Approved Section 4.55 (2) Modification Application

No: SSD 6966 MOD 1 Granted on 19 August 2021

ONE SYDNEY HARBOUR

BARANGAROO

2 Secondary Facade - Louvred Metal Cladding - Elevation
1 : 25

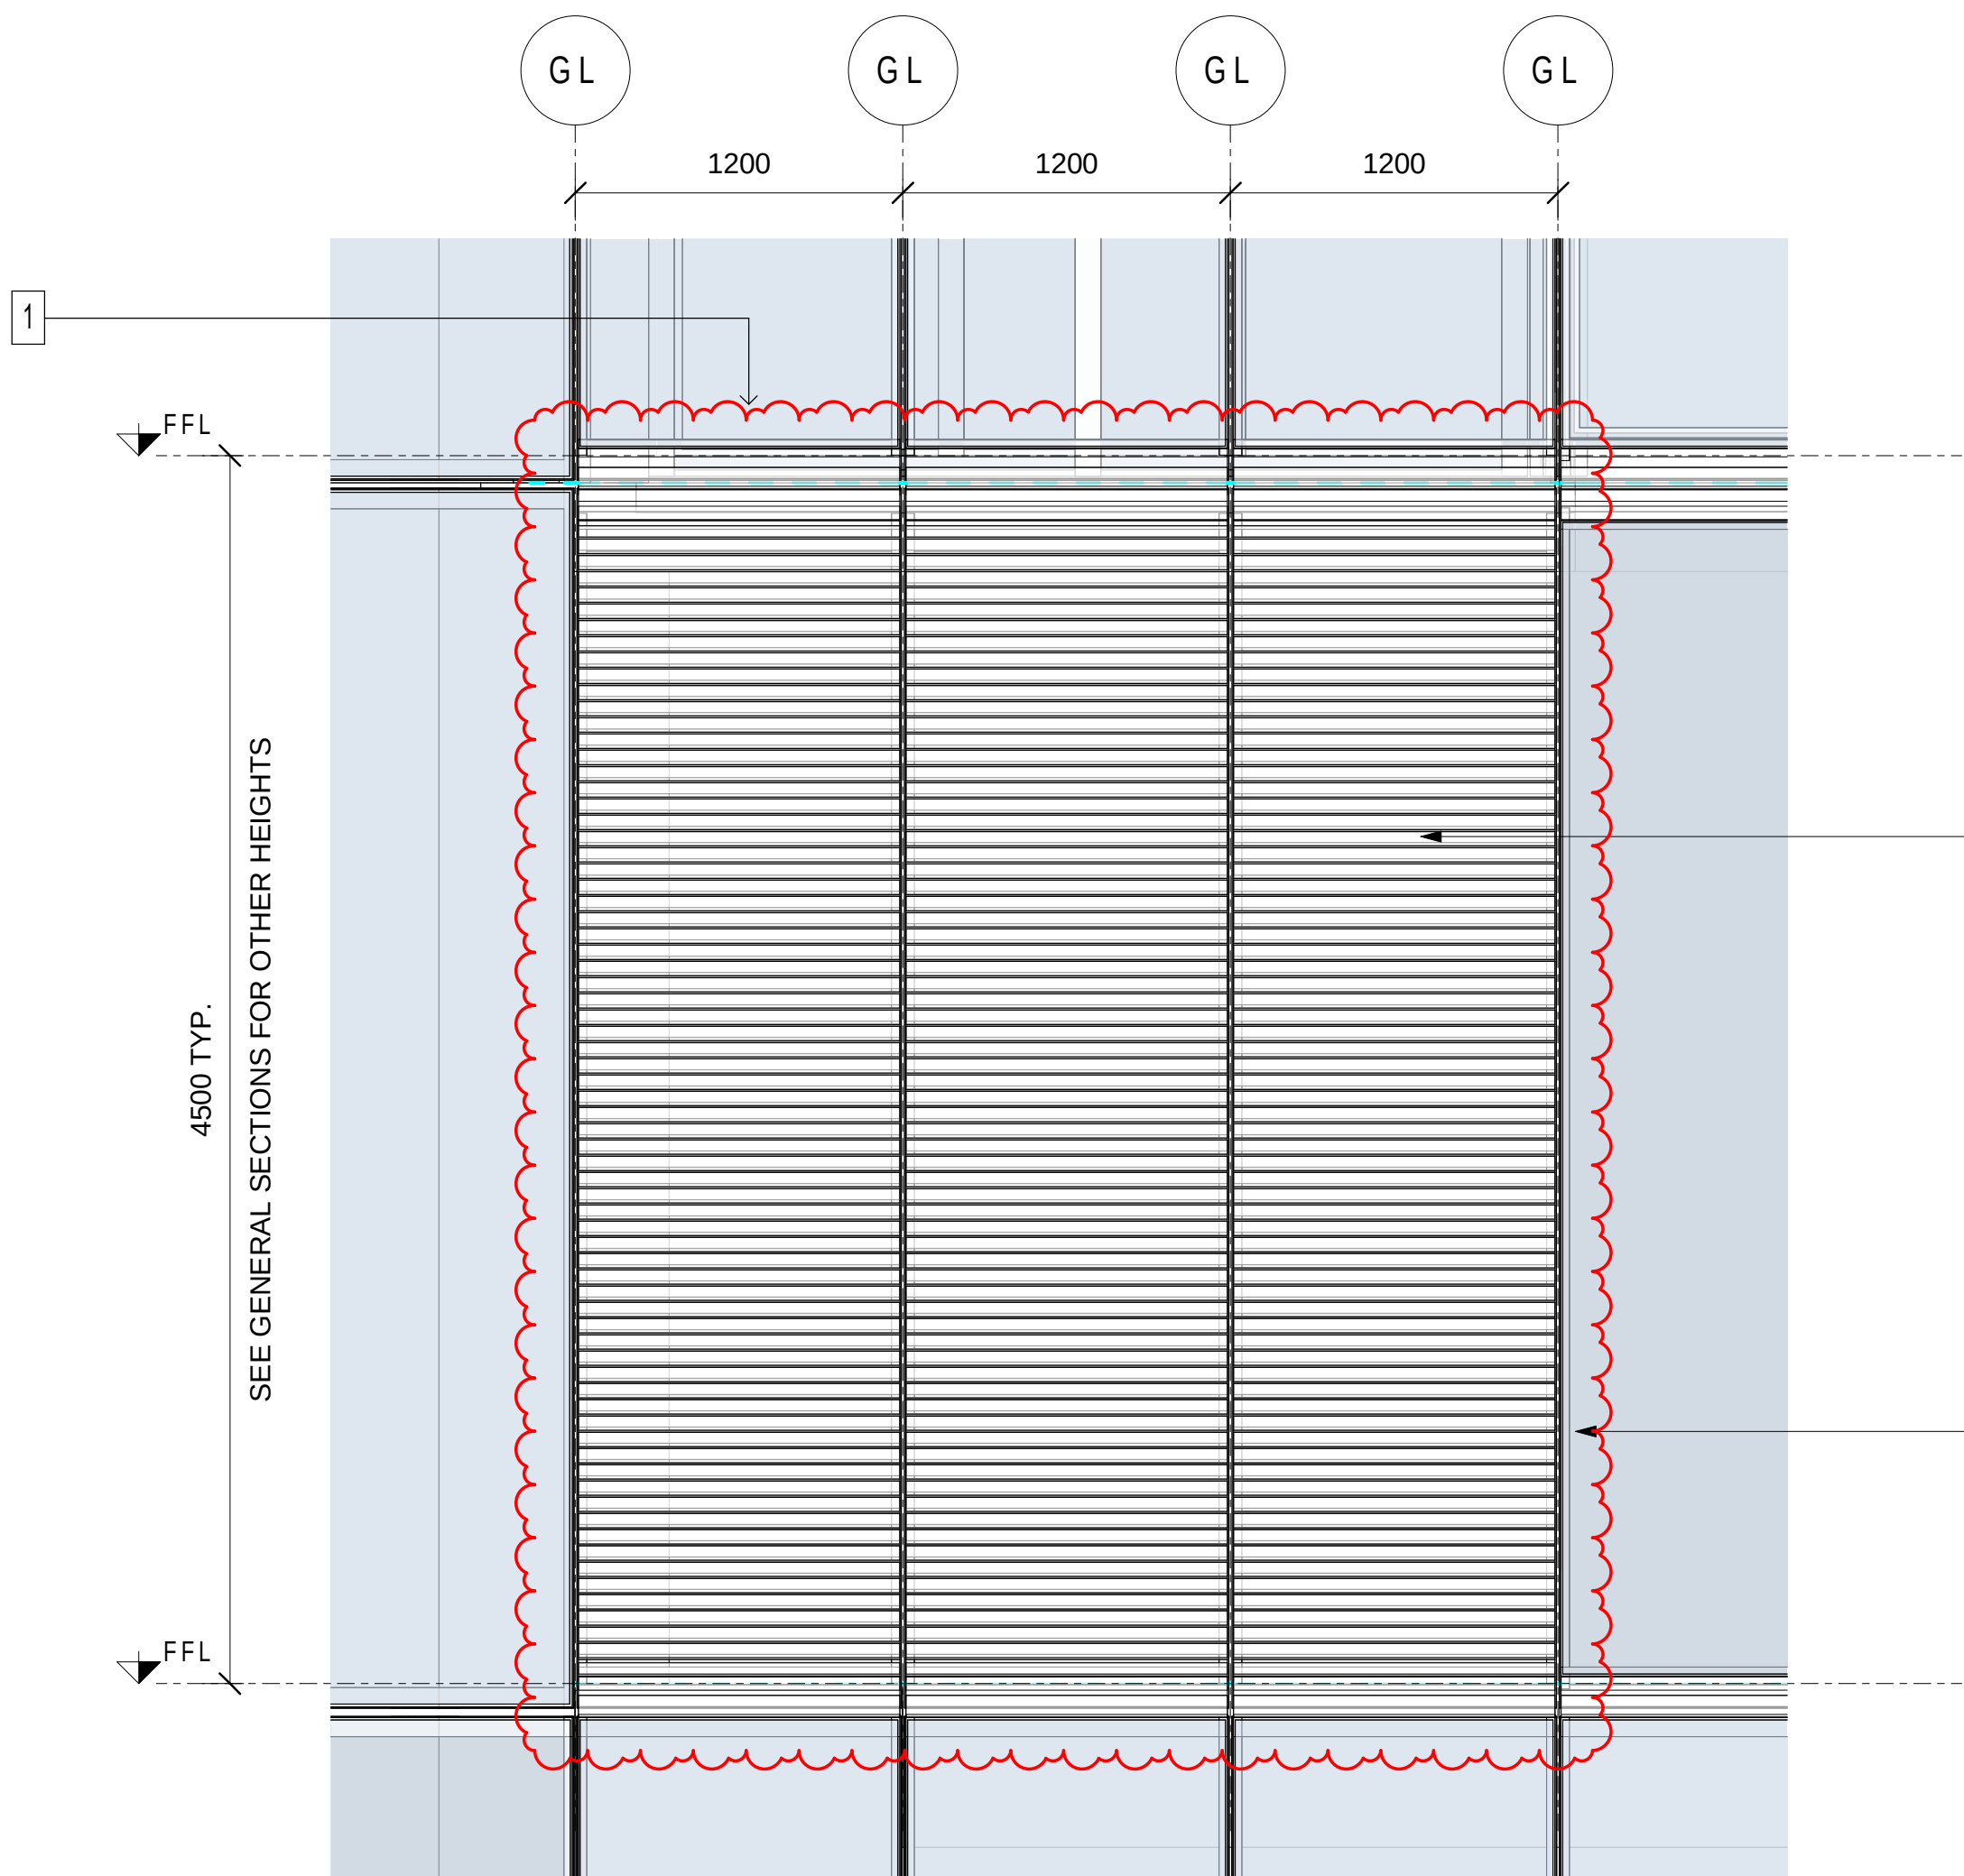
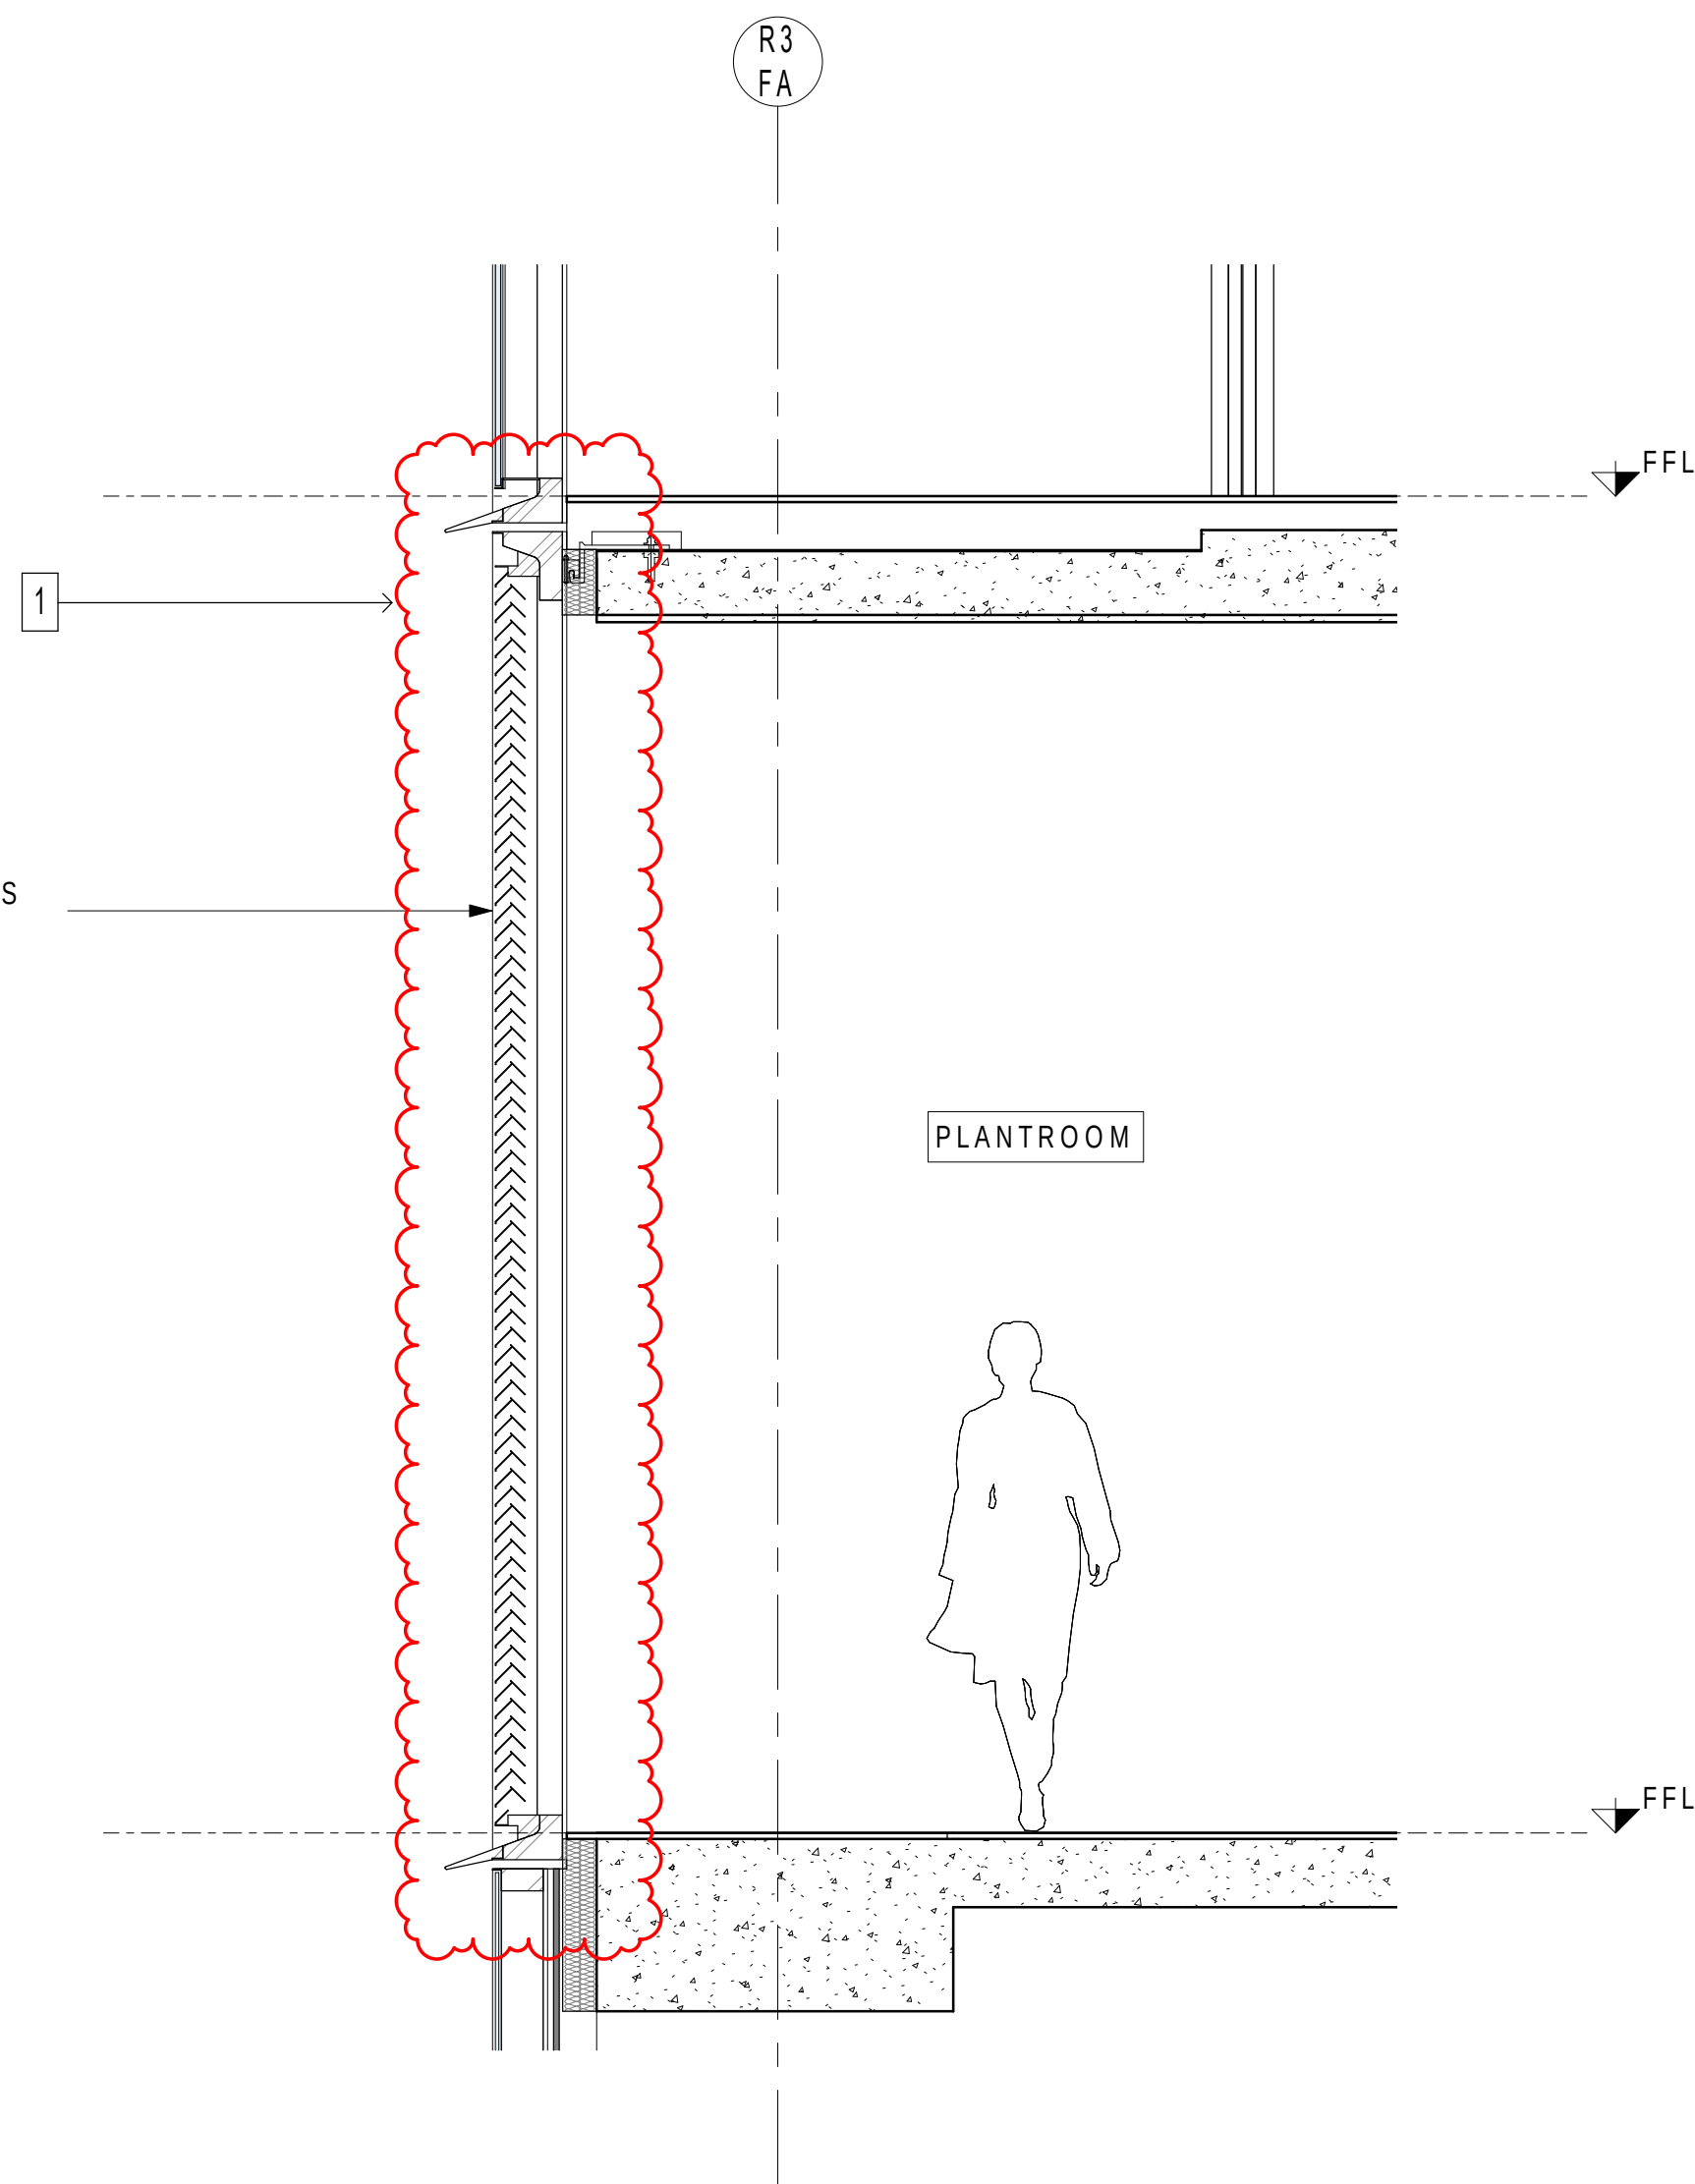
1. UPDATED LOUVRES GEOMETRY AND LOCATION
